## REPLACEMENT OF WASHER PART NO. 944072 (FLY WHEEL HUB) FOR ROTAX® ENGINE TYPE 912 AND 914 (SERIES)

SB-912-058UL

SB-914-041UL

### MANDATORY

**Fig. 1**

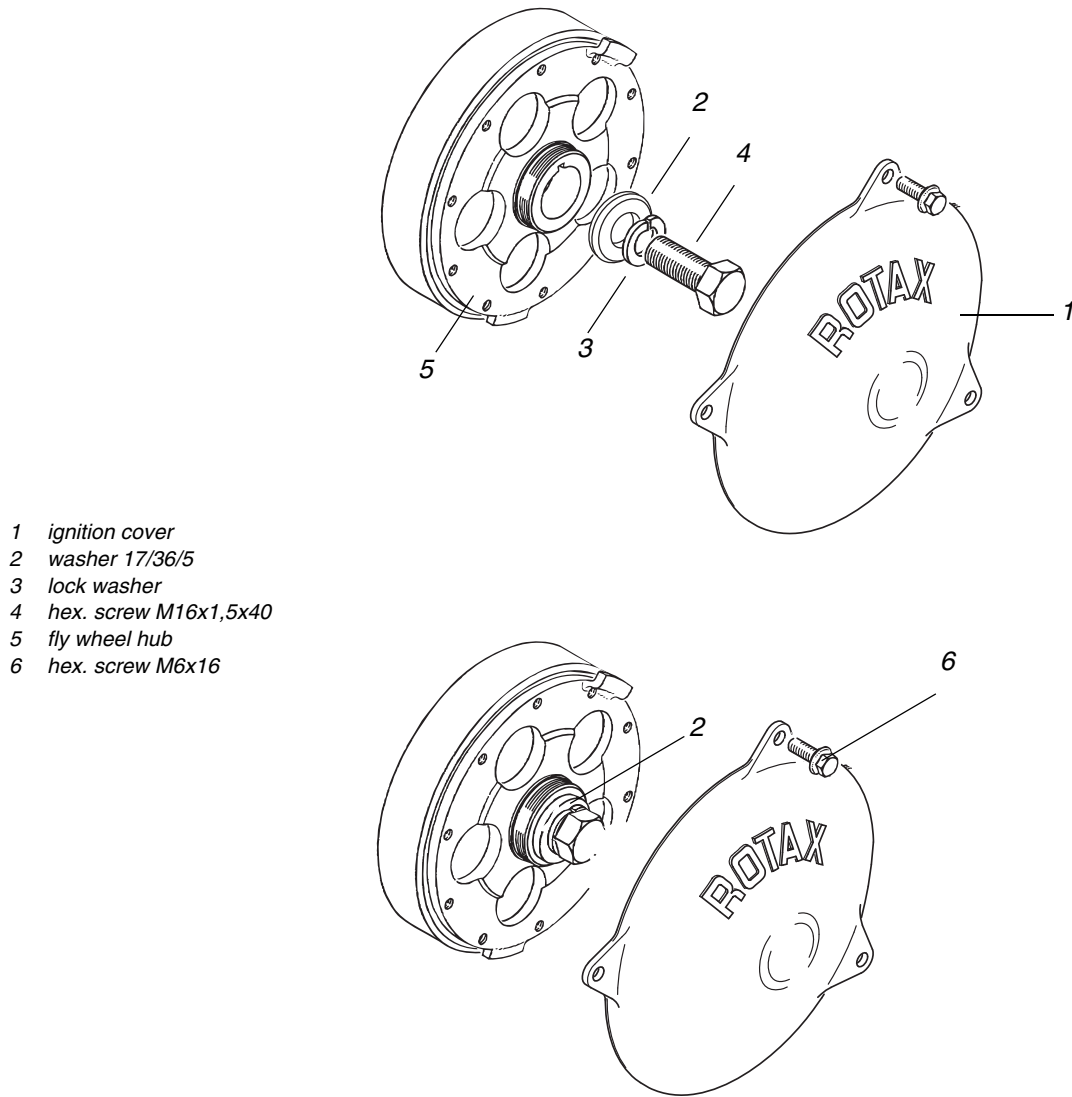
See fig. 1.

1. Remove ignition cover (1).
2. Lock the crankshaft in accordance with the relevant Maintenance Manual (Line).
3. Remove hex. screw (4) in accordance with the relevant Maintenance Manual (Heavy).

■ CAUTION: If the fly wheel hub has loosened during the disassembly and/or in case of doubt, then remove, clean and install the fly wheel hub in accordance with the relevant Maintenance Manual. In this case the tightening torque is 45 Nm (33.2 ft.lb) + 180° angle to rotation.

4. Install hex. screw (4). **Tightening torque 120 Nm (89 ft.lb).**

■ CAUTION: During installation the new washer (2) part no. 944072 must be used.

5. Remove locking pin of crankshaft in accordance with the relevant Maintenance Manual.
6. Check trigger coil gap, if necessary adjust it in accordance with the relevant Maintenance Manual.
7. Install ignition cover (1). The hex. screws (6) are locked with Loctite 221. Tightening torque 5 Nm (44 in. lb.).
